**RE: Supplemental Materials Submission for Special Permit Application PB#371, MIT West
Campus Graduate Student Dormitory at 269-301 Vassar Street**

MIT West Campus Graduate Student Dormitory

Planning Board Special Permit Submission

Supplemental Narrative

Figure 1 – Block 7 Map

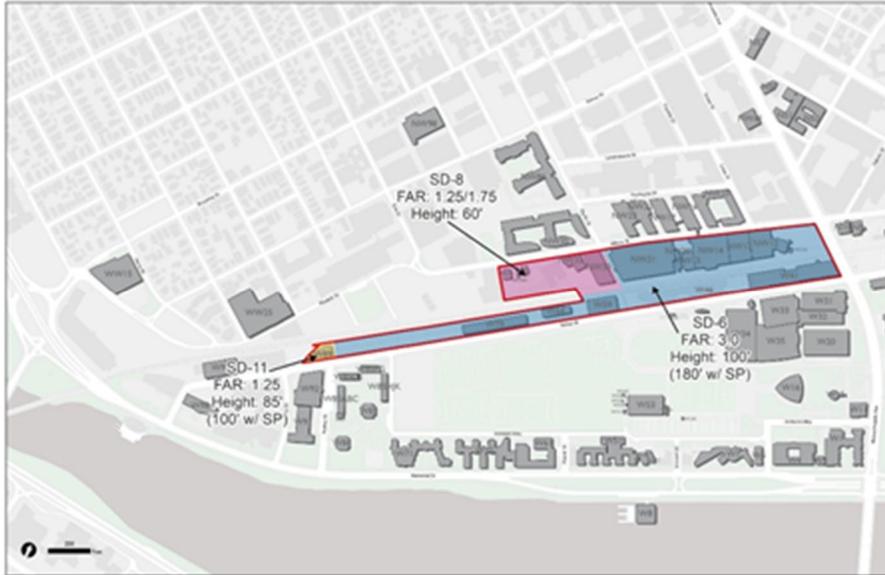
- **Maximum Floor Area Ratio (FAR).** The Site is part of the multi-building Zoning Lot owned by MIT referred to as “Block 7”, measuring 765,106 square feet in total as shown in Figure 1 below. Portions of the Zoning Lot are in the SD-6, SD-8, and SD-11 Districts, which districts have a maximum FAR for dormitory use of 3, 1.75, and 2, respectively. As detailed in Table 3, the total build capacity allowed on the Zoning Lot is 2,102,877 square feet of GFA. The existing buildings total approximately 1,118,831 square feet of GFA, allowing for approximately 998,955 square feet of additional development capacity, after the MIT Police Station is demolished. *The Project proposes up to approximately 328,050 square feet of GFA, creating a total of 1,431,972 square feet of GFA on the entire multi-building Zoning Lot, which is within the available capacity.* Accordingly, the Project complies with the maximum FAR requirement.

Zoning District	Zoning Block Area	FAR (Dorm)	Total Block Capacity (GFA)	Existing GFA on Block	Built Space to be Demolished	Remaining Block Development Capacity	New GFA
SD-6	608,466	3	1,825,398	968,481	n/a	n/a	
SD-8	143,206	1.75	250,611	135,441	n/a	n/a	
SD-11	13,434	2	26,868	14,909	14,909	n/a	
TOTAL	765,106	n/a	2,102,877	1,118,831	14,909	998,955	328,050
